Manual 12, Balancing Operations Revision 57 – Annual Review

System Operations Subcommittee
April 1, 2026

Revision 57 (05/26/2026):

- Removed “Dispatching Timeline” exhibit and supporting language.

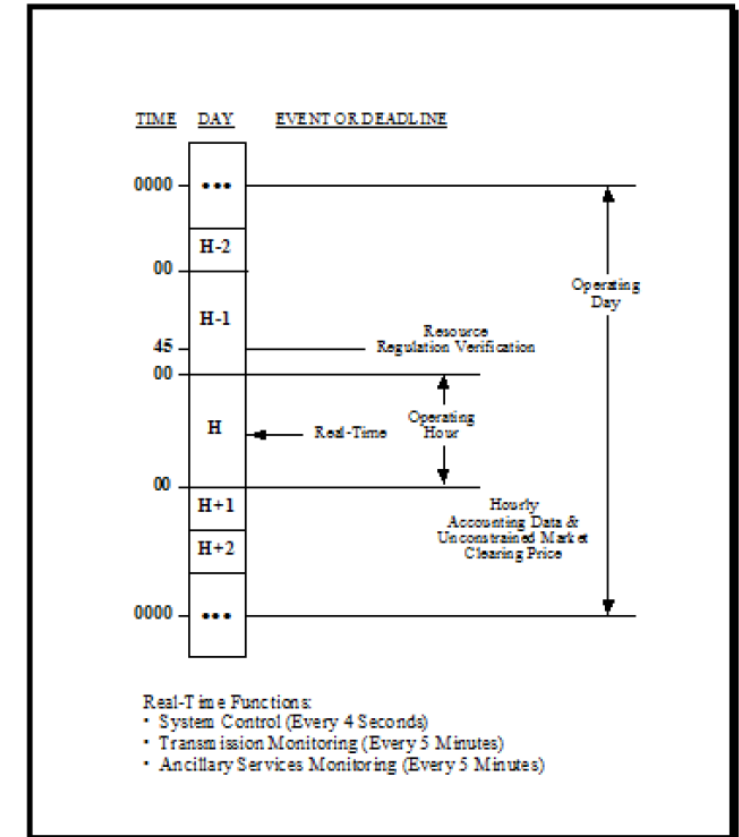
In PJM Manual 12, Balancing Operations, we focus mainly on the Dispatching Operation activities that take place in the current hour of the Operating Day. ~~The following exhibit presents the dispatching activities in the form of a timeline. The reference point for the timeline is the Operating Day, the daily 24 hour period beginning at midnight for which transactions on the PJM Interchange Energy Market are scheduled. This timeline type of description is used throughout this PJM manual.~~
